Subject Property:  
1258 FENWICK GARTH,  
ARNOLD, MD, 21012

The request is for a Critical Area Expanded Buffer Variance under the Anne Arundel County Zoning Code.

### CONFIRMATION OF PRE-FILE (2025-0004-P)

1 ADMIN SITE PLAN  
 1" = 30'-0"

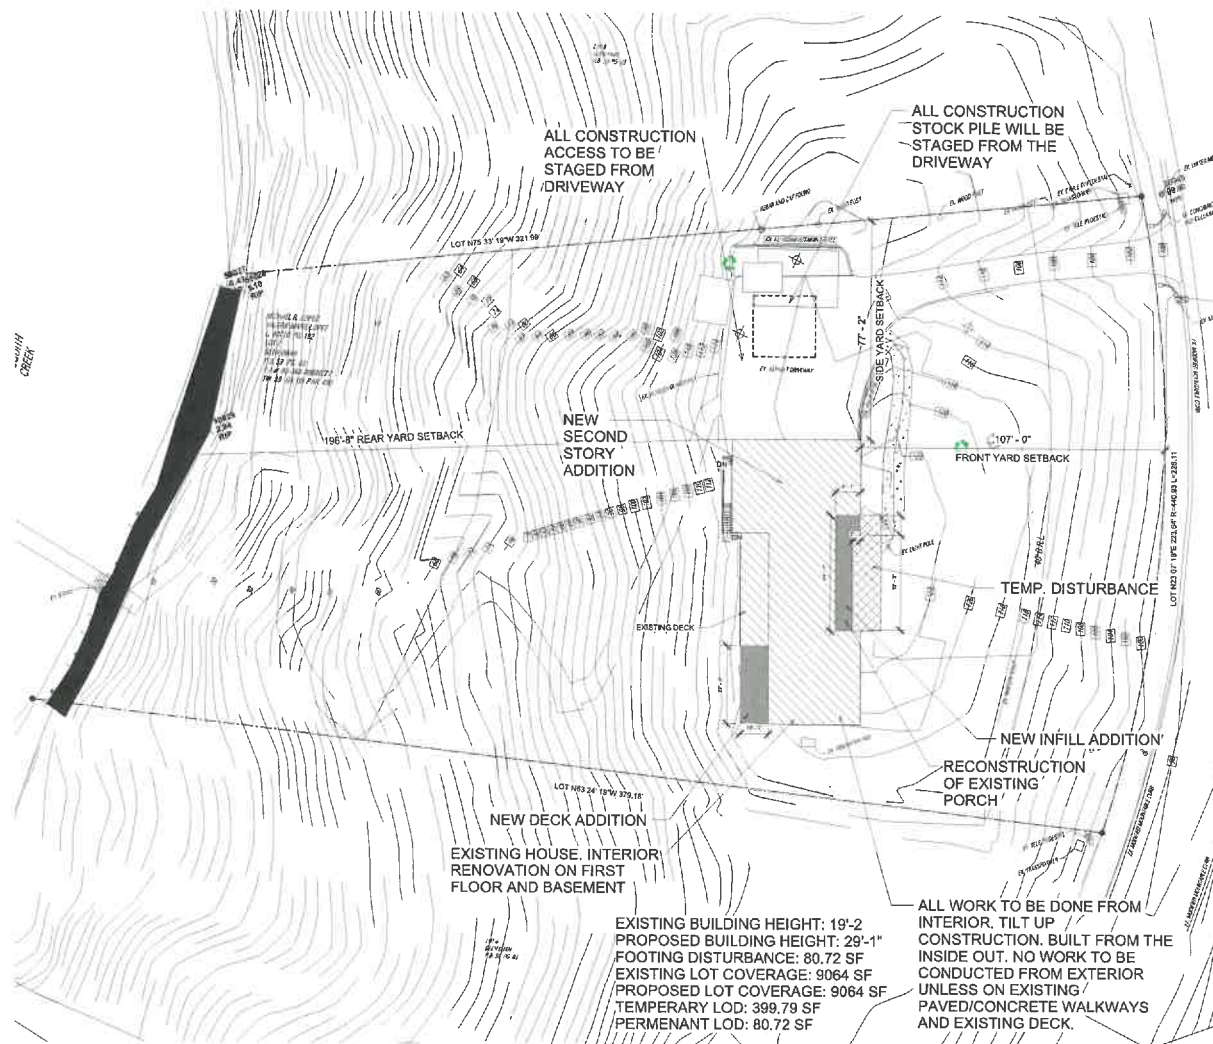
**Zoning Administration Section:** The site plan will need to label the existing and proposed height of the dwelling as well as the number of stories. Architectural drawings would be helpful in understanding the scope of work proposed. The letter of explanation does not provide any justification for the variances and also does not address any of the variance criteria. The application will need to address these issues and provide a thorough explanation. The extent of the second floor addition is unclear and the site plan should be updated to clearly show where the second floor addition will be constructed. No lot coverage calculations were provided and must be provided with the application.

EXISTING BUILDING HEIGHT: 19'-2"  
 PROPOSED BUILDING HEIGHT: 29'-1"  
 FOOTING DISTURBANCE: 80.72 SF  
 EXISTING LOT COVERAGE: 9064 SF  
 PROPOSED LOT COVERAGE: 9064 SF  
 TEMPORARY LOD: 399.79 SF  
 PERMANENT LOD: 80.72 SF
